RE: Review of Chestnut Hill College's (CHC) Landscaping Plans for the Sugarloaf – Germantown Avenue Entrance

PAGE C-701, LANDSCAPE PLAN: RECOMMENDATIONS

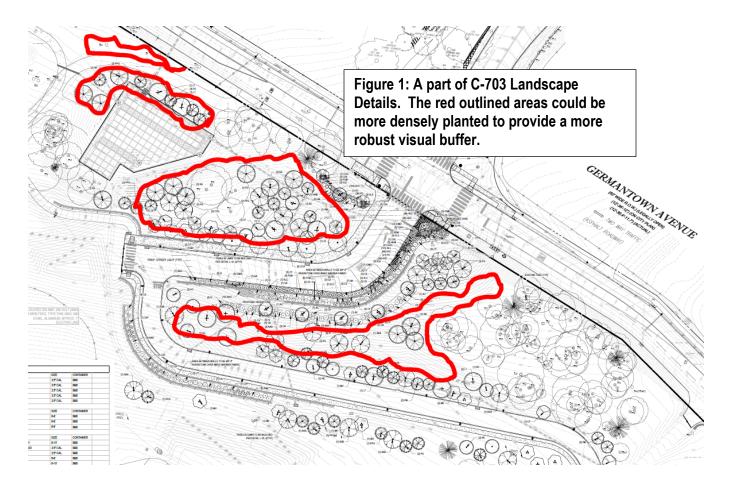
The proposed planting adjacent to Germantown Avenue seems to be a landscape-type planting design where the proposed trees/shrubs are generally about 20' on center. I feel a "landscape-type" treatment has precedence and is fine for Sugarloaf's interior spaces but assert that the area in the Germantown Avenue viewshed should be treated more as a reforestation project than a designed landscape in this area. This assertion does not include the entrance area which has retaining walls and is heavily planted with perennials. In a sense, my recommendation is to put back a higher density of trees which, before construction, was acting as a visual buffer.

To accomplish this goal, the red outlined areas shown in Figure 1 should be planted with about 50 more large maturing trees. If protected from deer browse and rub (see "Planning for Deer" section), these additional trees can be installed at a smaller size (~1.5" cal).

When planting near existing trees, care should be taken by the contractor, and the bid documents should specify, that no existing roots >1/2" shall be cut to install new plant material and that the new plants should be moved if there is a plant/tree root conflict as to not impact larger tree roots.

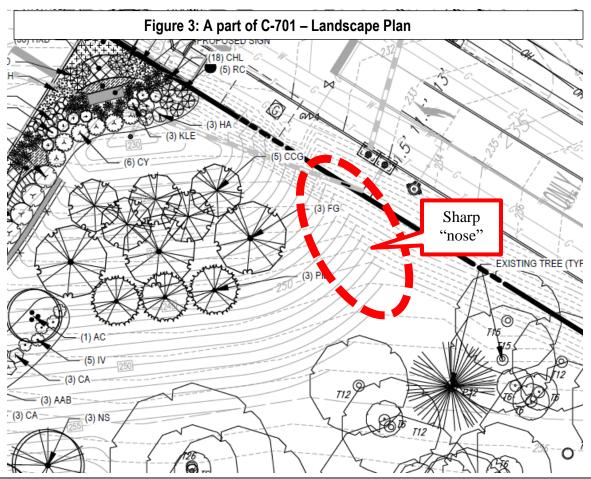
Although I am not a Landscape Architect, Architect, etc., I noticed an area that may need to be regraded. It seems that the highlighted area will have a very sharp corner and slope in the area shown in Figure 3.

Comments on L-1 Deciduous & L-2 Evergreen tree planting details

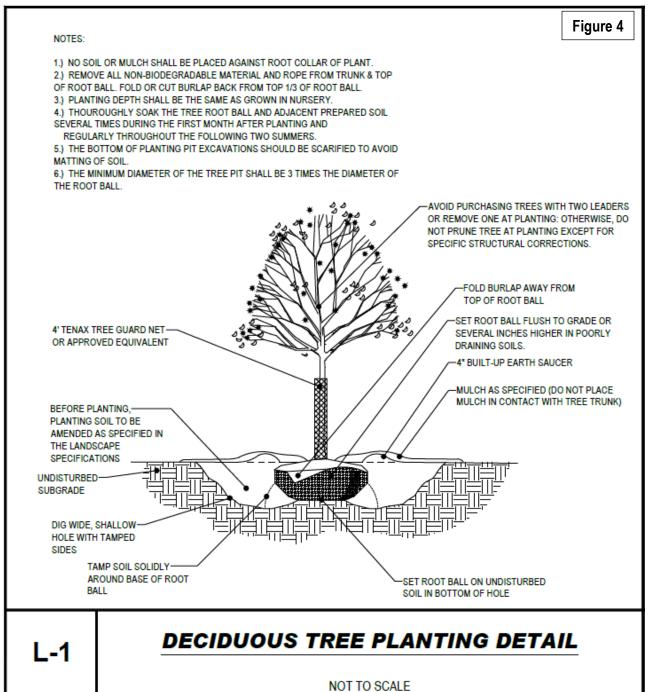
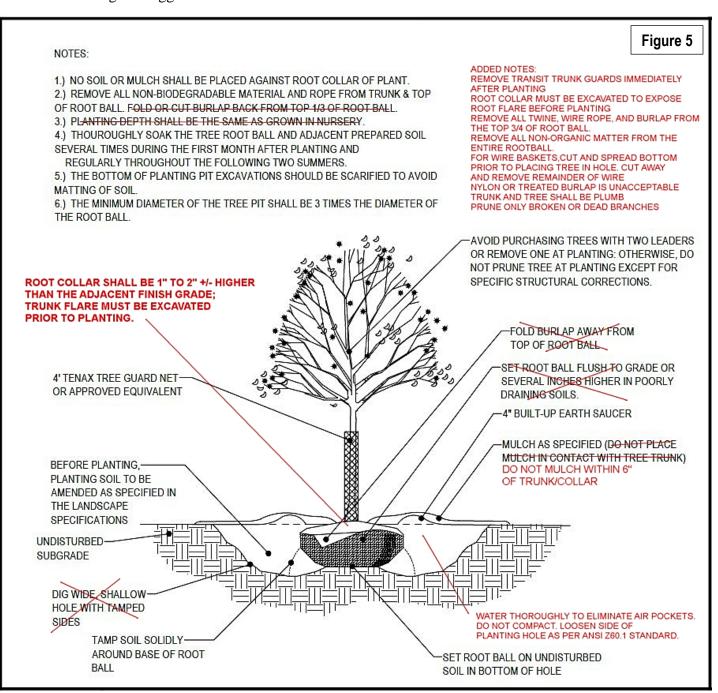
Deep planting is the #1 malady of newly planted trees. Therefore, the top of the root ball must be untied and the trunk flare¹ must be excavated before the tree is planted to determine the tree's planting height in the pit.

Another recommendation is to remove all man-made material from the top 3/4 of the root ball. The method of doing this is to backfill from the bottom, in 4-6" lifts, and rolling the next 4-6" of burlap and wire up the root ball and repeating this process until all the material can be removed. This methodology is illustrated in Appendix A.

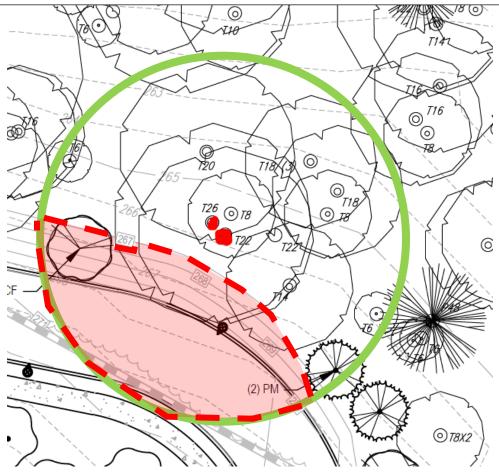
Figure 7: The tree protection zone (green circle for this example) for trees T22 and T26 may be severely compromised by the road installation and grading (red shaded area). Without anticipating this impact, this tree may have a significantly shortened safe and useful lifespan and my need to be removed five or ten years after construction is completed.

Given the method specified (drip line or at least 15' from trunk) for identifying the tree protection zones in the specifications, I recommend that the Urban Forestry Consultant's calculate the TPZ for all retained trees that could be impacted by construction, place these zones on a CAD plan, and if necessary, calculate the amount and severity of incursion into the TPZ. A findings/recommendations report should be submitted to the project team to determine the best course of action and tree protection for these trees.
